SCOPE OF APPLICATION | APPLICATION  
F&B portfolio 3-pole | Cable quality S3930

PCN26\_001

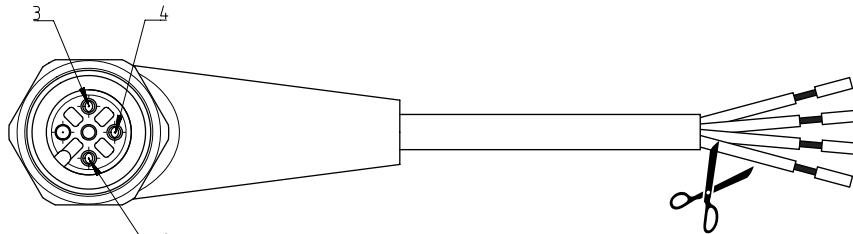
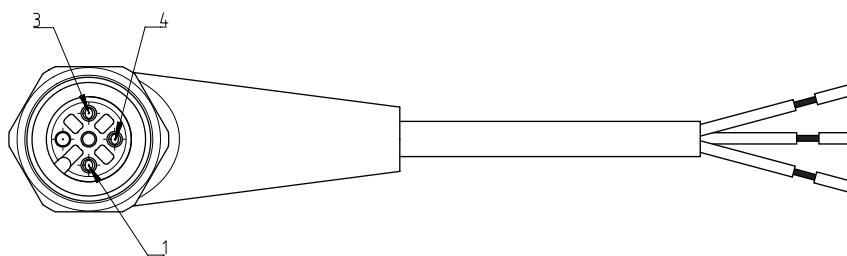
As part of our ongoing product optimization and our commitment to sustainable solutions, we are adapting the design of the cable used.

Previously, a 4-wire cable was used to manufacture the 3-pole version, with the excess wire being cut off. In future, we will switch to the direct use of a 3-wire cable.

- The guaranteed electrical and mechanical properties remain unaffected by this change.
